16 December 2022

**Re: Bowdens Silver Project (SSD 5765) – Feasibility of Open Cut Pit Extension**

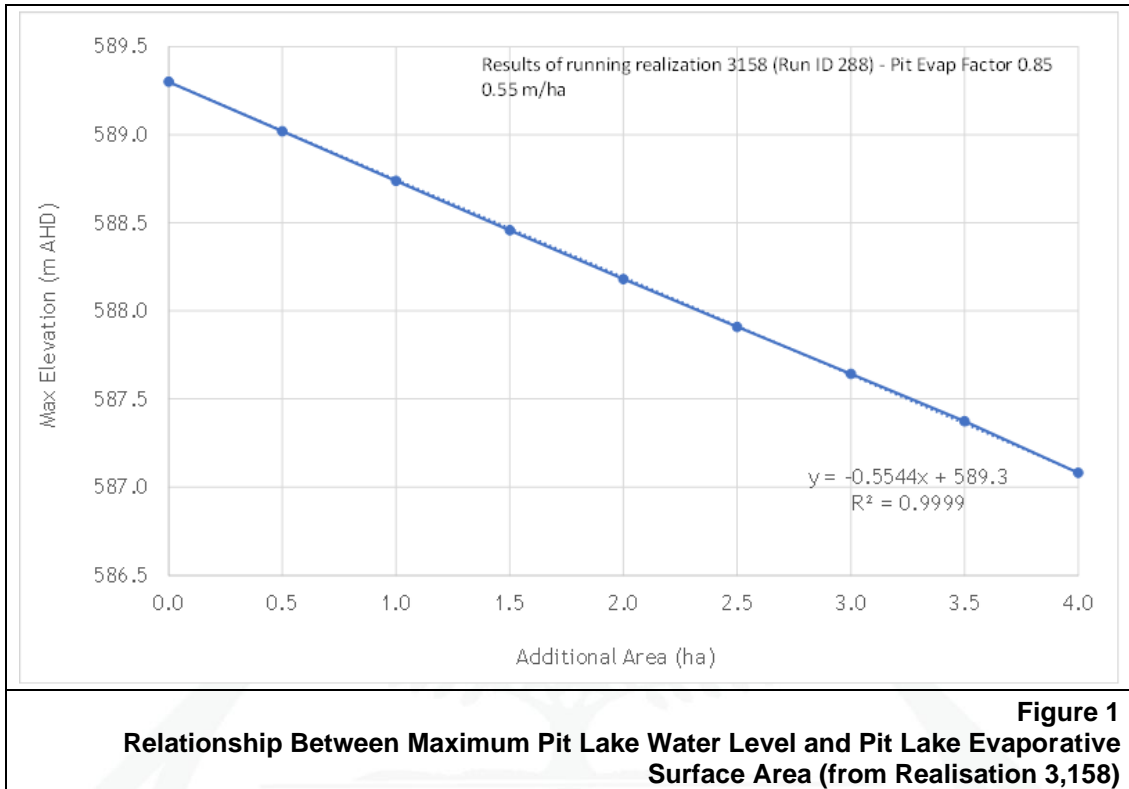
Following review of the *Bowdens Silver Project Groundwater Assessment Review* prepared by HydroGeoLogic we note the following comment with regards the possible mitigation measures presented in the *Bowdens Silver Final Void Uncertainty Analysis Report* (the Uncertainty Analysis Report) to mitigate against through flow risk.

*the suggested mitigation options (Corkery 2022b<sup>1</sup>) reduce but do not remove the risk of throughflow conditions developing*

Based on the relationship presented in Figure 15 of the Uncertainty Analysis Report (reproduced below as **Figure 1**), the addition of 1ha to the final void lake’s surface area would result in a water level reduction of 0.55m. This reduction is due to the increased evaporative loss from the lake that would occur from the larger water surface area. Importantly, to have this effect the increase must be to the lake surface area and not the total surface area at the top of the open cut pit.

1. Scenario 1 - Extension of the final void pit lake surface area by 12ha at an elevation of 577m.AHD. Based on the relationship shown in **Figure 1**, this scenario would reduce the 65<sup>th</sup> percentile peak water level of the Uncertainty Analysis Report (583.6m.AHD) to 577m.AHD. A

2. Scenario 2 - Extension of the final void pit lake surface area by 20ha at an elevation of 577m AHD. Based on the relationship shown in **Figure 1**, this scenario would reduce the 95<sup>th</sup> percentile peak water level of the Uncertainty Analysis Report (589.3mAHD) to 578.3mAHD. This level is below the previously estimated through flow threshold of 579mAHD. A final void water level of 589.3m AHD is described as “very unlikely” to occur in accordance with Table 2 of Middlemiss and Peeters (2018) (**Attachment 1**) and therefore was assessed as a worst-case outcome. This scenario was included to demonstrate the largest required extension to ensure that pit void lake levels remain below the through flow threshold of 579mAHD.

A final void lake level of 583.6mAHD is the upper bound of the Uncertainty Analysis Report outcomes described as “as likely as not”. This analysis demonstrates that this outcome may be mitigated by an open cut pit extension of 16.6ha (12ha increase to the lake surface) which would reduce the peak water level to 577mAHD, comfortably below the previously predicted through flow threshold level of 579mAHD. In the very unlikely circumstance that the final void pit lake reaches an equilibrium lake level of 589.3m AHD, a 28ha extension to the open cut pit (20ha increase to the lake surface) would reduce the water level to 578.3m AHD, also below the previously predicted through flow threshold level. The total volume of material to be removed from the currently proposed open cut pit is approximately 32.5 million cubic metres<sup>3</sup> and this analysis indicates that between 8.6 million and 16.3 million cubic metres of additional material may need to be extracted and placed in the floor of the open cut pit to mitigate through flow risk.

Bowdens Silver has reviewed the proposed post-closure extension strategy and accepts that an open cut pit extension between 16.6ha and 28.0ha may be required to satisfy its commitment to construct a final void that would remain a groundwater sink. All efforts would be applied during development to remove this risk, however it is a feasible outcome for the Company given the circumstances. There is more than sufficient area within the existing disturbance envelope to extend the open cut pit post-closure and the above analysis demonstrates that this extension would depress the final void pit lake water level to an elevation at which through flow would be unlikely. Bowdens Silver has previously committed to updating the regional groundwater model during mining operations and would undertake further detailed assessment of final void behaviour and anticipated pit lake water levels during mining operations.
